Draft Campsie Master Plan Site Specific Review

Joint Panel Report

Site C1: 124–142 Beamish Street and 16–18 Ninth Avenue

Figure 11: Site C1 Height (in storeys)

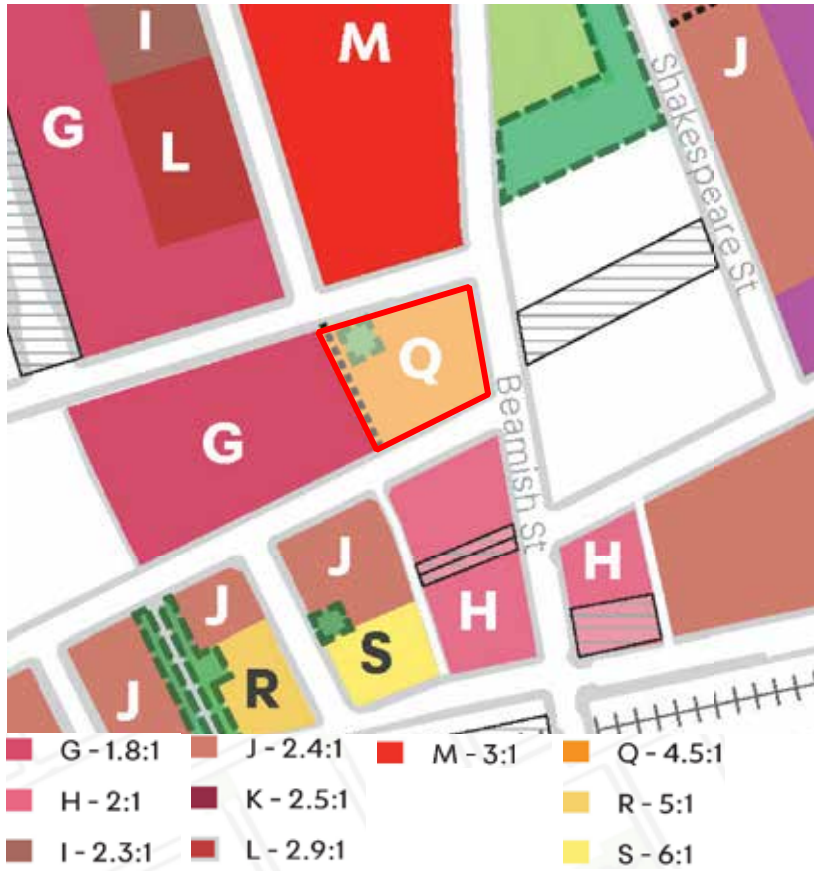
The draft Master Plan has determined, from significant analysis and with reference to the Tall Buildings study, that 20 storeys is a maximum building height for Campsie. It is sufficient height to recognise this site's landmark location while allowing a more successful transition to the lower development heights for surrounding land. The Panel considers that the draft Master Plan height of 20 storeys should therefore not be increased.

- Maintain the maximum 20 storey building height.
- Provide a consistent 3 storey street wall to all street frontages to clearly define the prominent corner site.

Figure 16: Option D – Ground Floor Plan

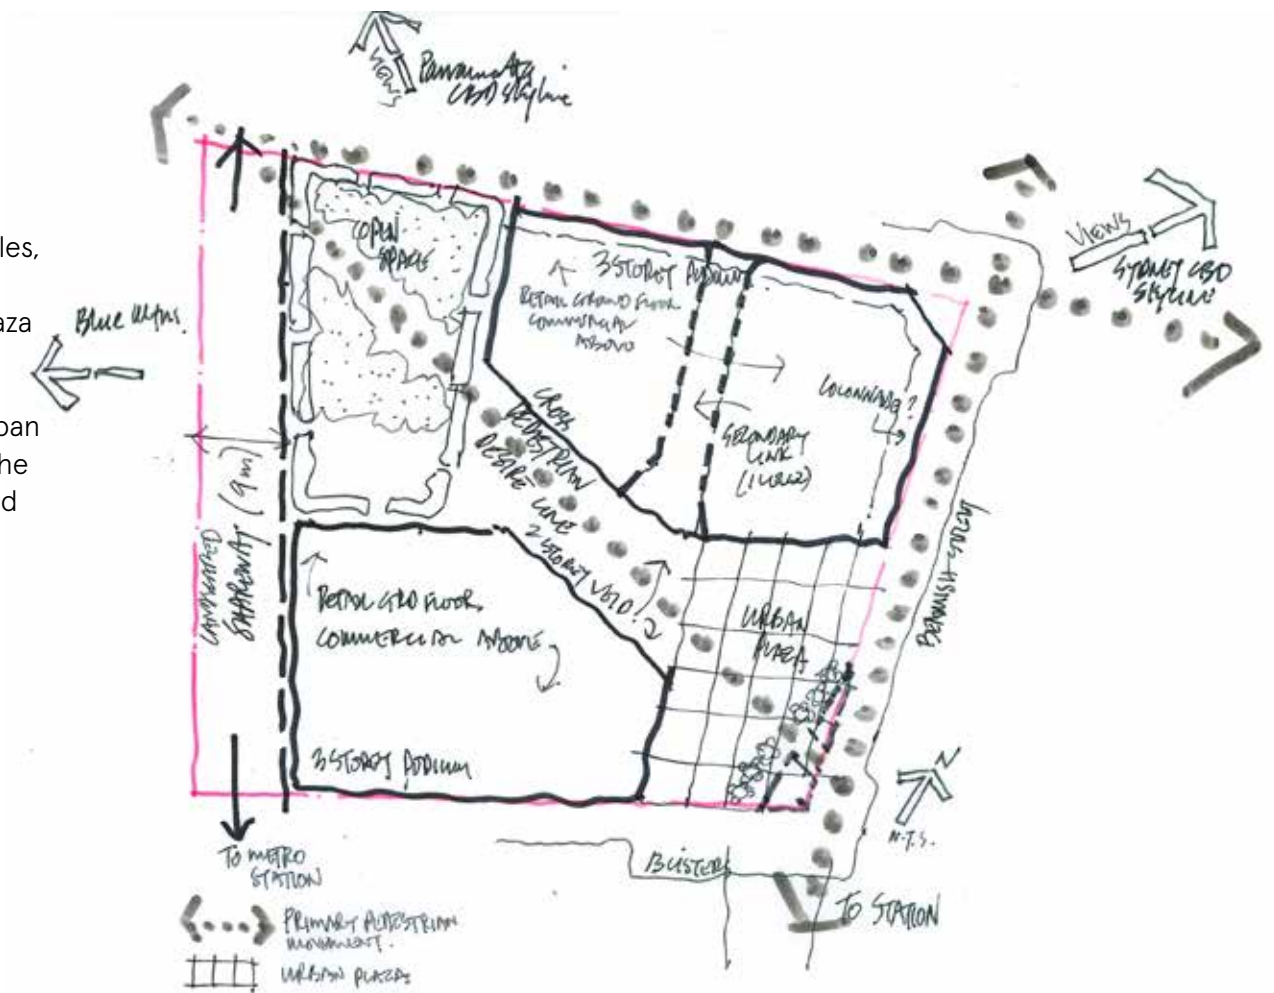
After considering these different options, and in the interest of broadening an understanding of potential approaches, the Panel identified a further potential option. This "Option D" would see built form reinforce the street corner, a 3-storey podium forming street-walls with an urban plaza to the south east corner and a single tower (800m²) in a generally north south orientation parallel to Beamish Street and Ninth Ave. Refer to Figure 16 and Figure 17.

A three storey street wall (to all street frontages and a new urban plaza) is consistent with the maximum street wall height contemplated in the draft Master Plan. It would also support increased floor space for employment generating uses, noting that is one of the key principles of the draft Master Plan, to support and catalyse growth of Campsie as a strategic centre. Furthermore, a three storey street wall is an appropriate design response on this site which occupies an entire city block. It would define the street edge at a scale consistent with other main street development and, relative to a lower street wall, would be more effective at diminishing the visual impact of the tower in views from Beamish Street and a new urban plaza.

Taking into account all design considerations, site analysis and Council's testing, the Panel consider that the draft Master Plan maximum FSR control can be increased from 4.5:1 up

to a maximum of 4.9:1. Development up to this maximum would enable an optimal development outcome which is consistent with other draft Master Plan controls and principles, is appropriate in the context and includes the potential for additional public benefit in the form of new public urban plaza addressing Beamish Street.

Figure 24: Section showing solar and visual impacts on Anglo Road Properties

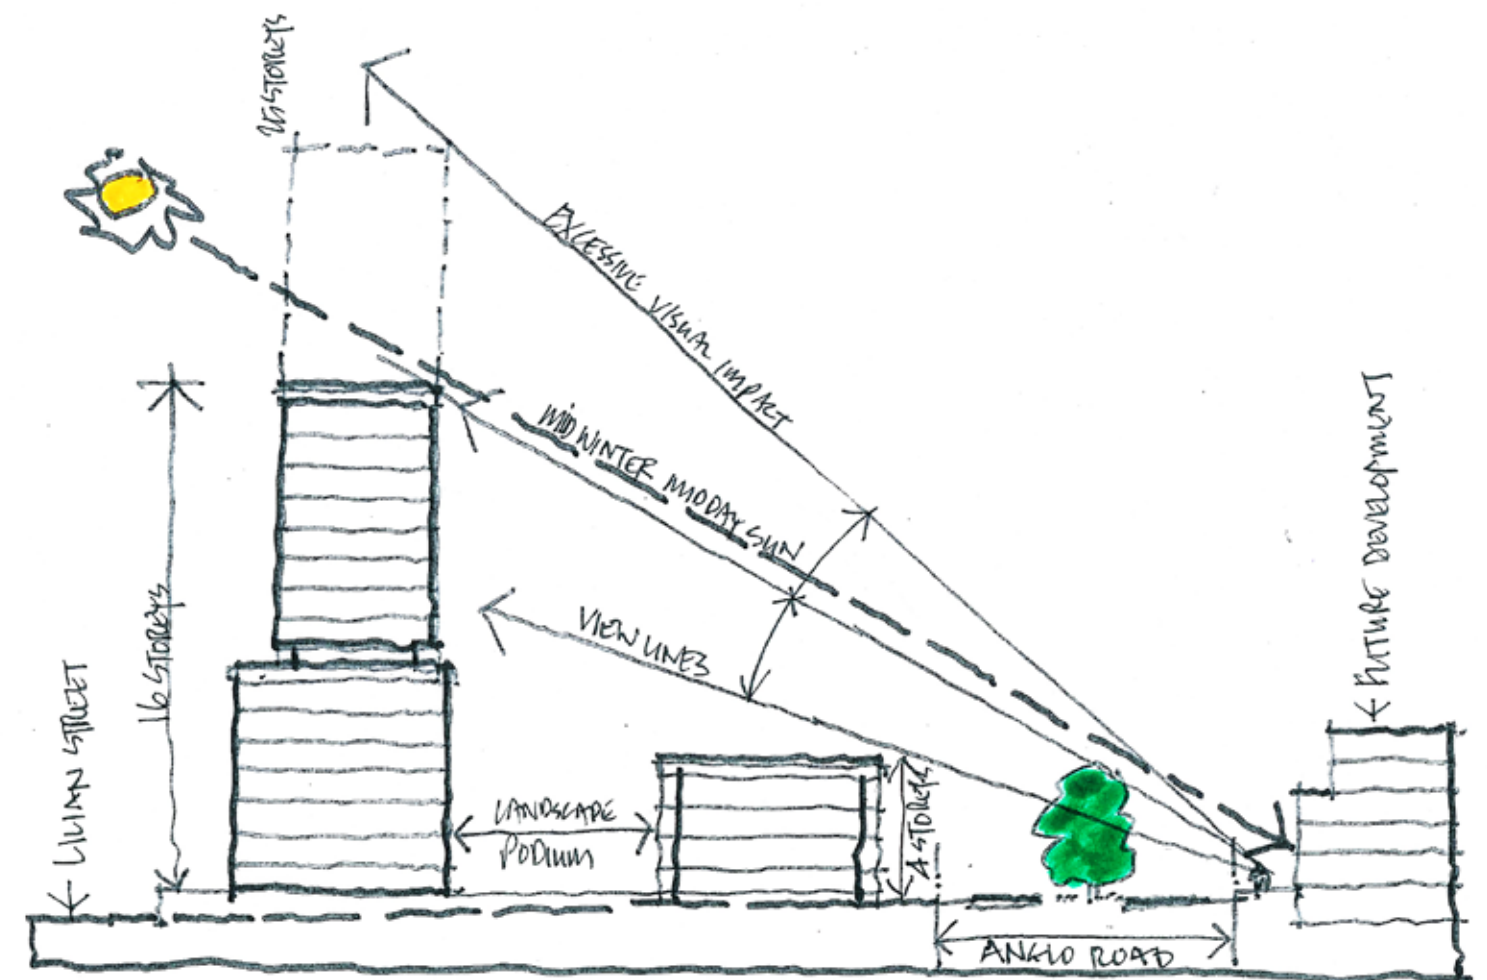
The proposal demonstrates acceptable overshadowing impacts for Anzac Square, Carrington Square and surrounding streets. However, the proposed 25 story tower would result in shadow impacts for future development to the south side of Anglo Street which the draft Master Plan seeks to avoid.

Refer to Figure 24

The modelling confirms that the Panel's preferred built form outcome can be achieved with the 3.2:1 FSR currently proposed in the draft Master Plan. There is potential to take better advantage of the incentive floorspace provisions for underground space and address urban design issues, as outlined below.

A higher building may be possible in the north-east corner of the site (west of the laneway) The proposed 4 storeys could potentially reach 8 storeys. If this approach were pursued the building length along Lilian Street would need to be addressed in design development.

Figure 25: Built form with defining edges to ANZAC Park and active frontage

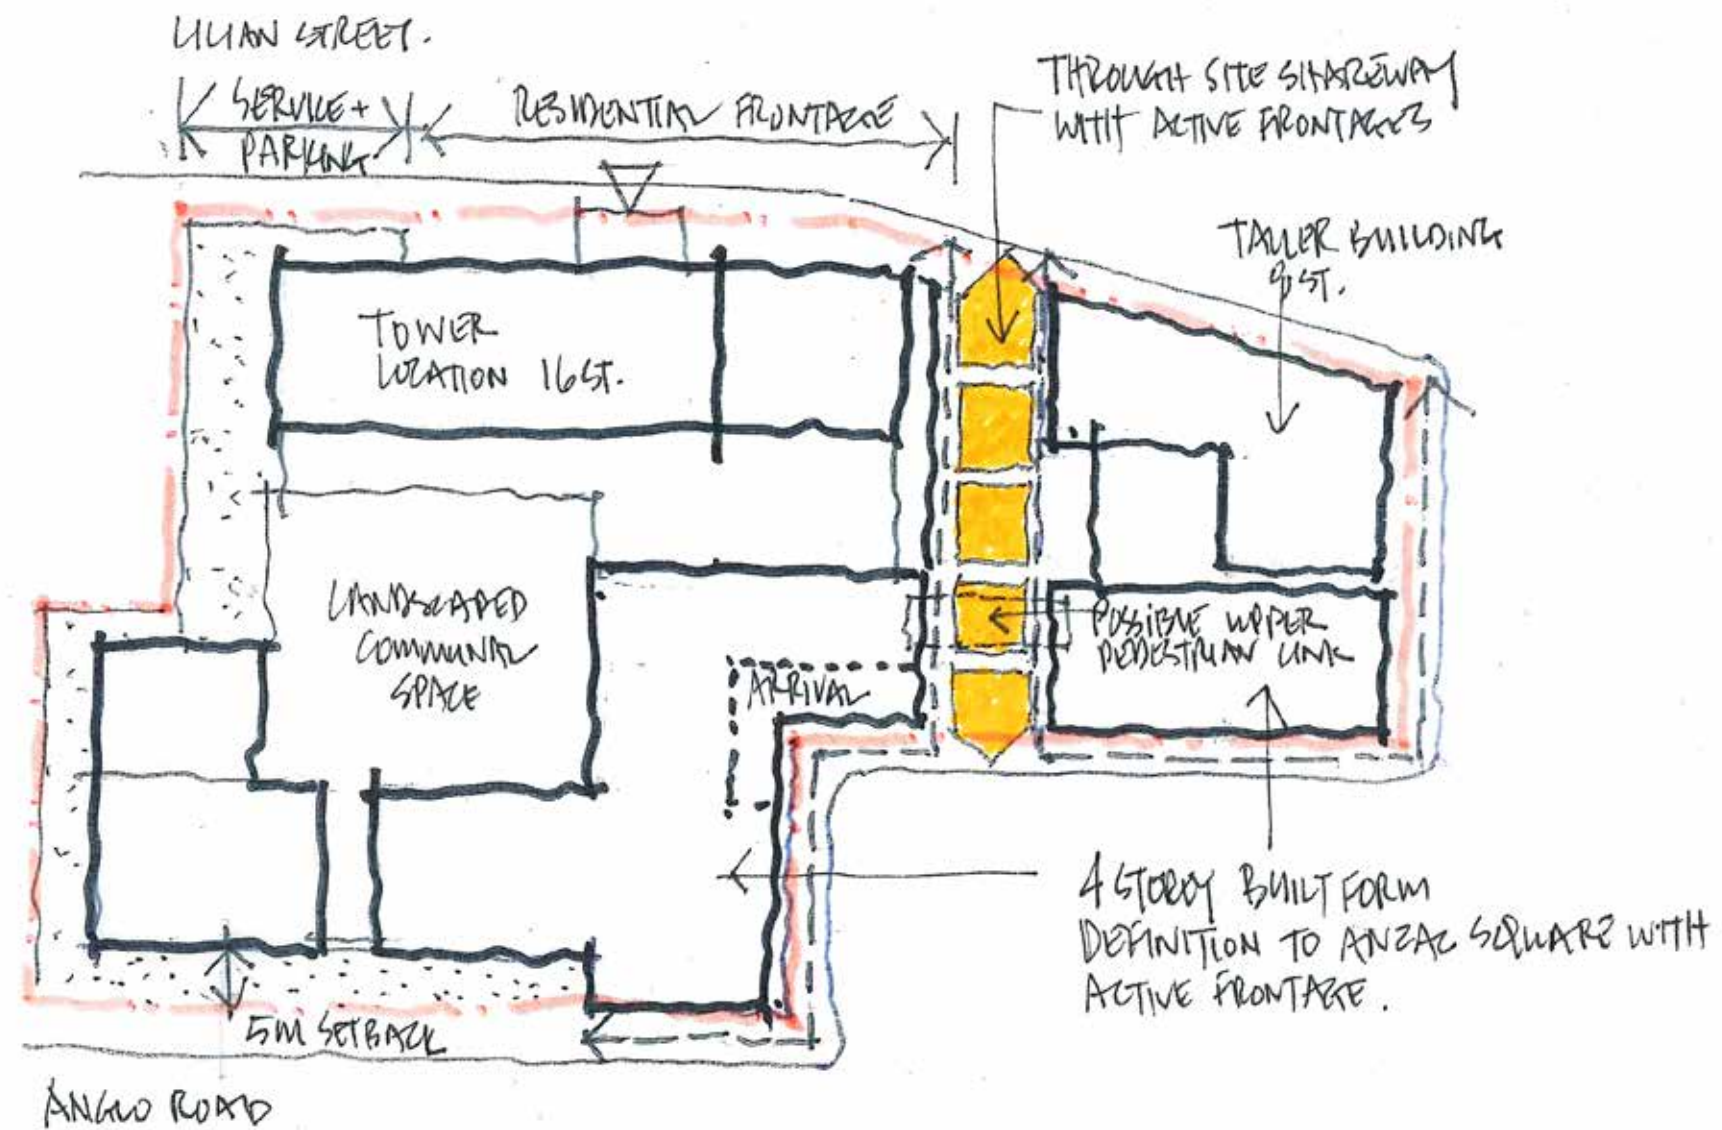
Despite these commercial factors, this approach limits preferred built form and urban design outcomes for the site. A more holistic approach to redevelopment may provide the opportunity for:

- a 4 storey street wall to Anzac Park, for more consistent building edge to the park, consistent with the draft Master Plan;
- relocation of some or most of the Club floor area below ground, providing for a greater yield, consistent with the intent of the draft Master Plan; and
- a more considered approach to activating the Dewar and Lilian St frontages, refer to Figure 25.

Figure 30: Site C3 FSR

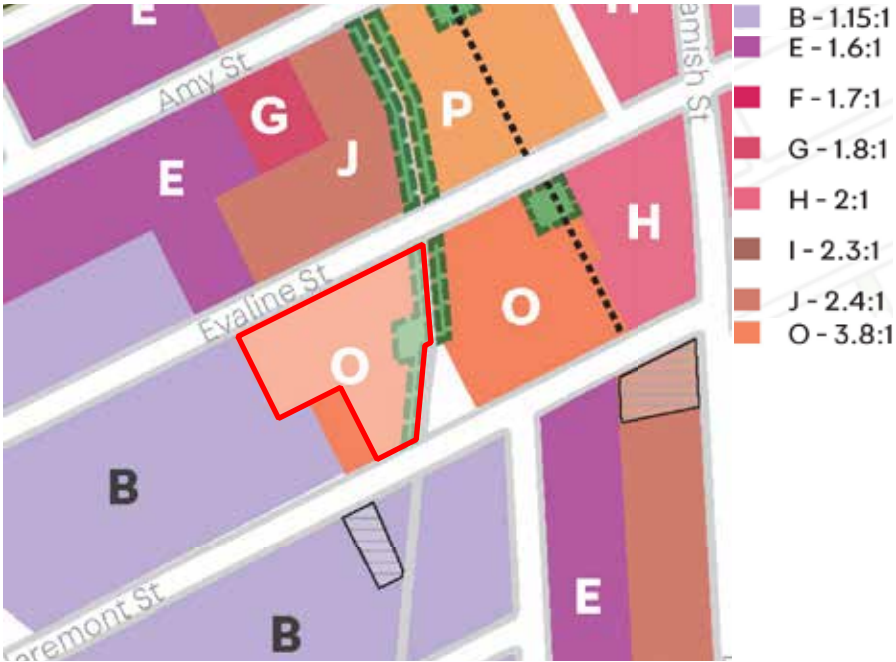
Taking into account the impact of overshadowing, Council's testing of floor space with modelling of both the proponent's submission and the above defined building envelopes has determined that an FSR above the draft Master Plan maximum of 3.8:1 (not including potential underground floor space) cannot be achieved.

Figure 31: Ground floor plan showing recommended setbacks and key links

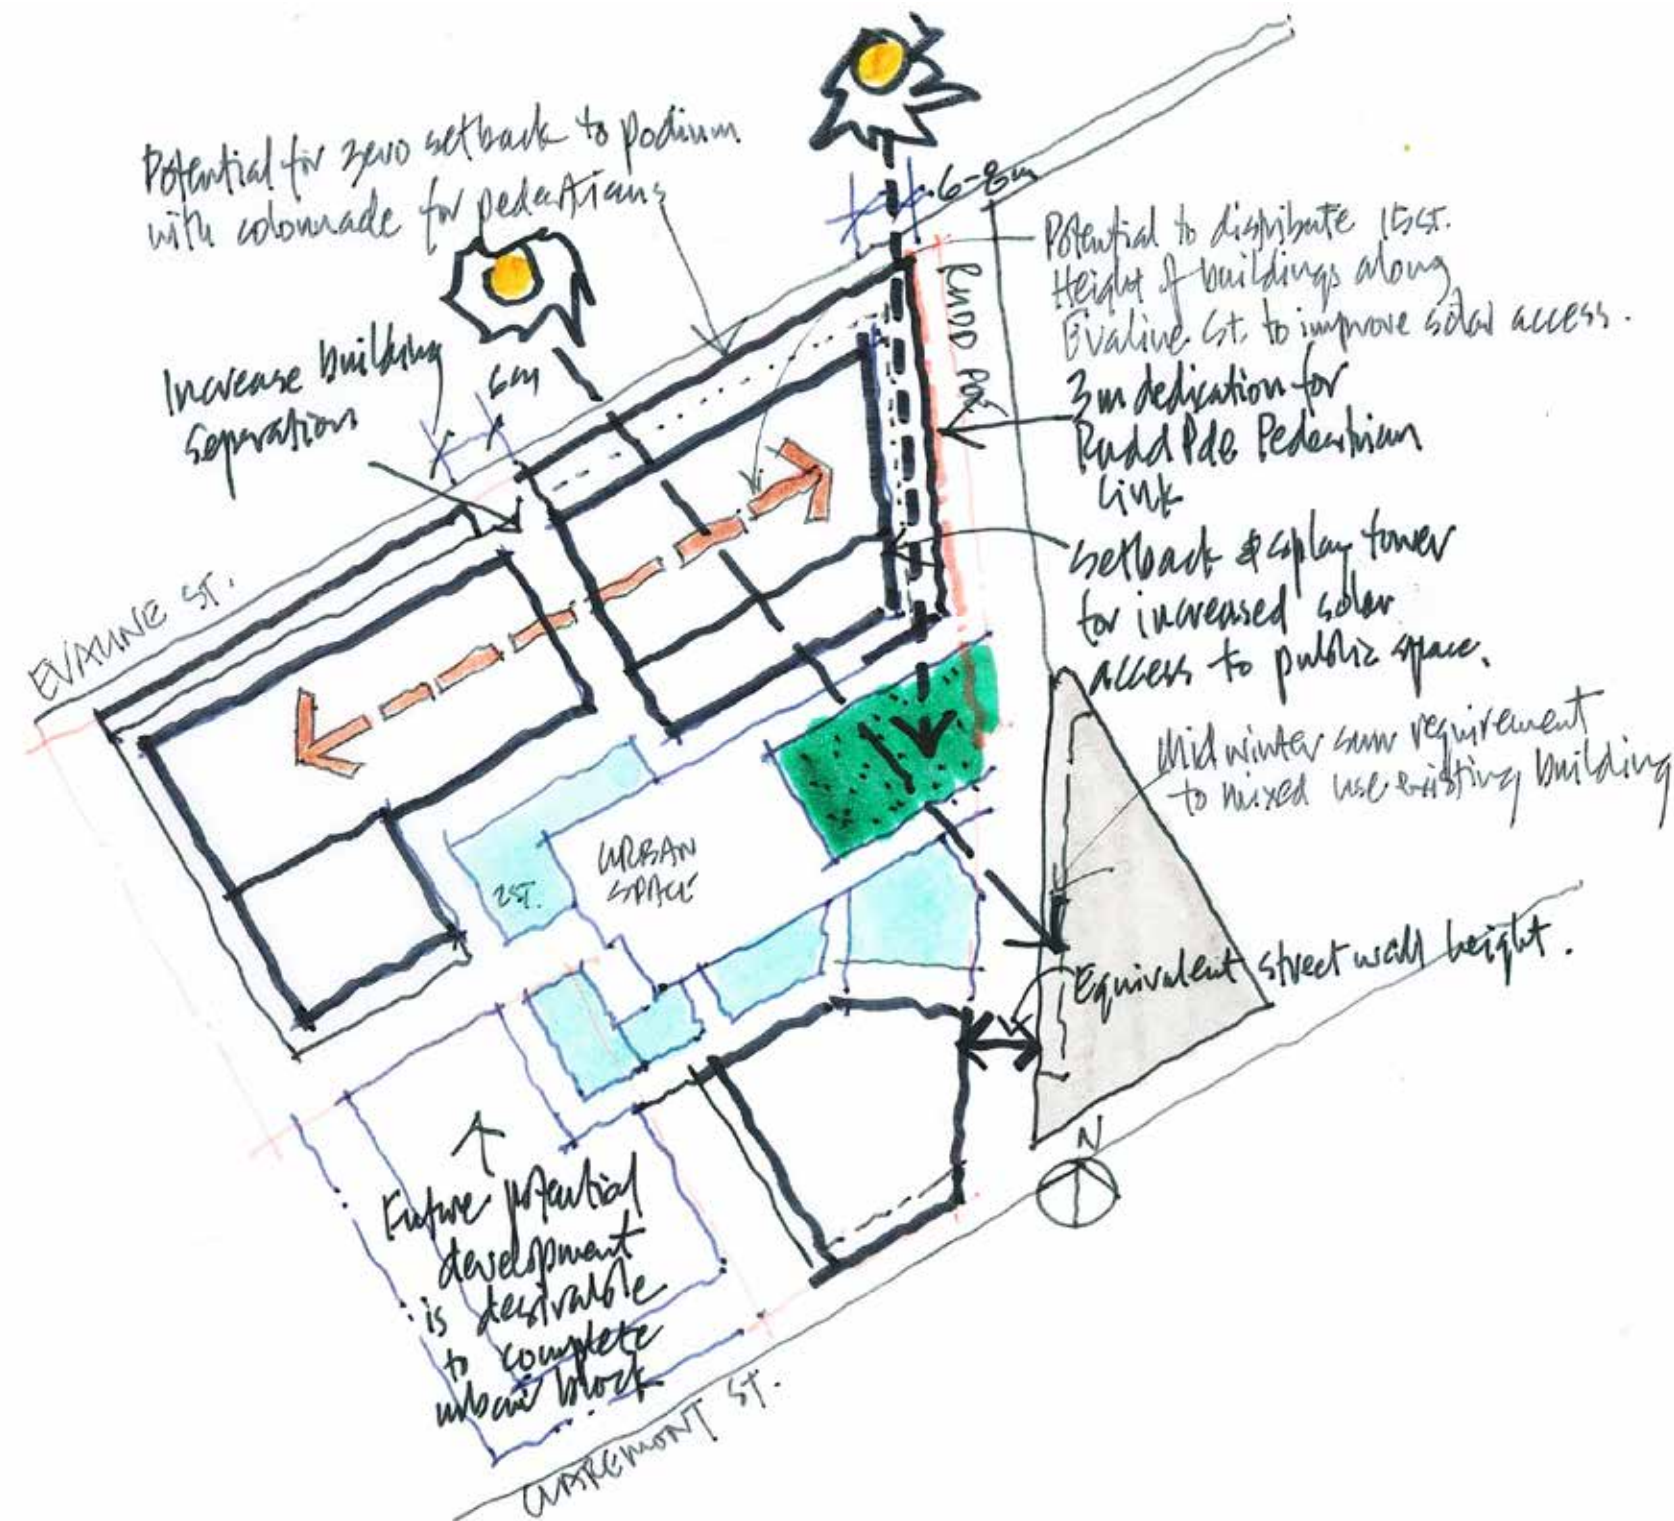
The overall scheme has well considered urban design merits. It would be considerably enhanced by inclusion of the three adjacent sites to the west on Claremont Street. A more regular block and built form would then define the south-west corner and provide better enclosure of the proposed central urban space.

The Panel recommend modifying the draft Master Plan height control to allow for a 15 storey tower to be located anywhere along the Evaline Street frontage to optimise solar access to the urban space and adjacent development. Related floor plate and built form separation controls are recommended to control building bulk while providing maximum flexibility during design development. The 3m building separation between the 15 and 8 storey buildings fronting Evaline Place is inadequate. It should be a minimum of 6m to improve airflow, noting that compliance with SEPP 65 and the ADG may require greater separation at development application stage.

The proposed zero setback of the southern building from Rudd Parade and Claremont Street is also supported with the proposed 3m colonnade to Rudd Parade. This street wall (5 storeys in the draft Master Plan and proponent's submission) is recommended to be reduced from 5 to a maximum of 4 storeys, for consistency with the adjacent wedge shaped mixed use building (on the corner of Rudd Parade and Claremont Street) and to be more responsive to lower scaled development on Claremont Street.

- existing and future potential development adjacent and south of the site's boundaries; and
 - the proposed internal urban space, noting the draft Master Plan requirement for solar access.

- Provide a minimum 6m separation between the tower and lower built forms fronting Evaline Street.
- Dedicate a 3m wide strip of the north eastern corner of the site (total of approx. 180m²) for a consistent 6m width to Rudd Parade.

The above recommendations are shown in Figure 31
